# Access Compliance Report

## Public Rights-of-Way

Intersection ID: 12589	Main Street: BELVEDERE_AV	Cross Street: TRUMAN_RD	Location: SW
ADA ID: 55C419C16883	Ramp Type: PerpDiag	Initial Pass/Fail: Fail	Overall Compliance: No
Codes/Mitigation Info/Possible Solution		Field Measurements/Component Compliance	
Severity Score: 8.75

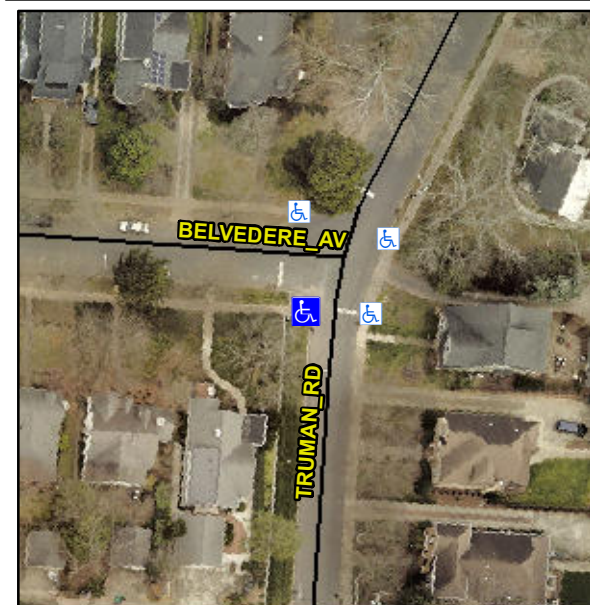
**Not Found, R304.5.1**

Compliance	Description	Data	Compliance	Description	Data
N/A	Ramp Length (in)	49.0	Yes	Ramp Slope (%)	6.0
No	Ramp Width (in)	43.0	Yes	Ramp XSlope (%)	0.8
N/A	Flare Type LT	N/A	N/A	Flare Type RT	N/A
N/A	Flare Slope LT (%)	N/A	N/A	Flare Slope RT (%)	N/A
N/A	Flare Traversable LT?	N/A	N/A	Flare Traversable RT?	N/A
N/A	Landing Length (in)	N/A	N/A	DWS Provided?	N/A
N/A	Landing Width (in)	N/A	N/A	DWS Contrast?	N/A
N/A	Landing Slope (%)	N/A	N/A	DWS Length (in)	N/A
N/A	Landing X Slope (%)	N/A	N/A	DWS Full Width?	N/A
N/A	Landing Curb? (Y/N)	N/A	N/A	DWS Offset (in)	N/A
N/A	Shared Landing?	N/A			
N/A	Gutter Ponding?	N/A	N/A	Gutter Slope (%)	N/A
N/A	Gutter Lip Ht (in)	N/A	N/A	Gutter X Slope (%)	N/A
N/A	Painted X Walk1?	No	N/A	Painted X Walk2?	No
	X Walk 1 Direction	To E		X Walk 2 Direction	To N
N/A	X Walk 1 Width (in)	N/A	N/A	X Walk 2 Width (in)	N/A
	X Walk 1 Slope (%)	0.1		X Walk 2 Slope (%)	3.9
	X Walk 1 X Slope (%)	0.6		X Walk 2 X Slope (%)	2.1

**Remove & Replace Curb Ramp With Two New Directional Ramps or Equivalent.**
